WATTS BAR NUCLEAR PLANT (WBN) UNIT 1 - AMERICAN SOCIETY OF
MECHANICAL ENGINEERS (ASME) INSERVICE INSPECTION (ISI) PROGRAM
REQUEST FOR RELIEF 1-ISI-16, 1-ISI-17, 1-ISI-18, AND 1-ISI-19
- REQUEST FOR ADDITIONAL INFORMATION (TAC NOS. MC 9638,
MC9639, MC9640, MC9641)

The purpose of this letter is to provide a response to NRC's
request for additional information dated April 27, 2006,
concerning TVA's request for relief dated January 25, 2006.

WATTS BAR NUCLEAR PLANT (WBN) UNIT 1
REQUEST FOR RELIEF
1-ISI-16, 1-ISI-17, 1-ISI-18, AND 1-ISI-19

WBN
RAI QUESTION #6
PRE-SERVICE VS ISI RPV EXAMINATIONS
COVERAGE OF REQUESTED WELDS

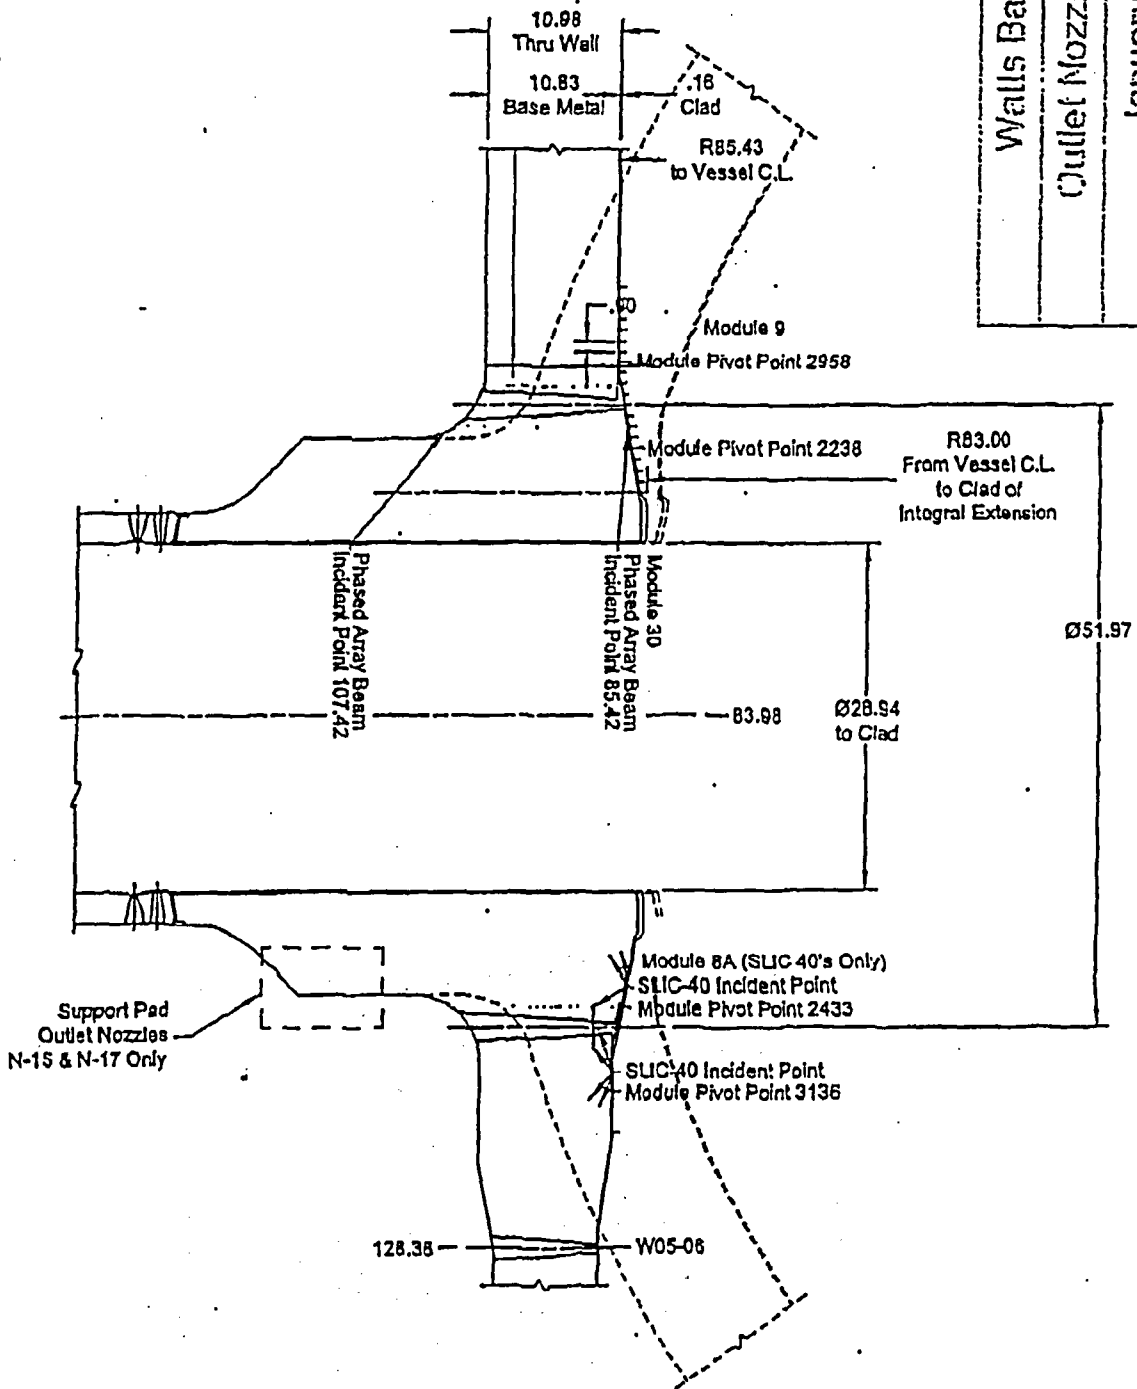
Compare the limitations on coverage of welds W01-02, W02-03, W2A, W2B, W2C, W2D, W2E, and W2F, with the limitations from any previous scans of the welds, such as preservice inspections, and explain any areas of less coverage than on previous exams. Discuss the results of the comparison.

The Pre-Service Examination of the WBN reactor vessel was performed during October-November, 1978. The exams were performed to the requirements of Section V and Section XI of the ASME Boiler and Pressure Vessel Code, 1974 Edition through the Summer 1975 Addenda. In accordance with Paragraph I-5213 of Section XI, only the limitations were required to be listed on the examination report. The requirement to calculate the extent of coverage was not required until Regulatory Guide 1.150,

"Ultrasonic Testing of Reactor Vessel Welds during Pre-Service and Inservice Examinations," dated June 1981 was issued. The Pre-Service Examination was performed prior to issuance of this regulatory guide. As a result, the limitation of each component was recorded by the obstruction, and no coverage estimates of the volume were calculated.

As a result, a direct comparison of the extent of coverage cannot be accurately determined. The 2005 Inservice Inspection was performed to Appendix VIII qualified PDI guidelines which utilize qualified personnel and techniques as required by 10 CFR 50.55a and Section XI.

A listing of the reported coverage and limitations for the inservice inspection and limitations for the pre-service inspection is included in Attachment 2.

ISI Weld #	% Coverage	Restrictions listed in ISI Report	% Coverage	Restrictions listed in Pre-Service Report
W01-02	60%	Limited to bottom head penetrations	None Performed	No Examinations from the cap side due to instrumentation tube interference
W02-03	72%	Limited due to proximity of core barrel stabilizing lugs	None Performed	Limited Examination due to core support lug interference.
W2A	79%	Limited due to the bottom head penetrations and core barrel stabilizing lugs	None Performed	Limited examination due to core support lug interference.
W2B	84%	Limited due to the bottom head penetrations and core barrel stabilizing lugs	None Performed	Limited examination due to core support lug and instrumentation tube interference.
W2C	85%	Limited due to the bottom head penetrations and core barrel stabilizing lugs	None Performed	Limited examination due to core support lug and instrumentation tube interference.

W2D	85%	Limited due to the bottom head penetrations and core barrel stabilizing lugs	None Performed	Limited Examination due to core support lug interference.
W2E	85%	Limited due to the bottom head penetrations and core barrel stabilizing lugs	None Performed	Limited examination due to core support lug and instrumentation tube interference.
W2F	67%	Limited due to the bottom head penetrations and core barrel stabilizing lugs	None Performed	Limited examination due to core support lug and instrumentation tube interference.
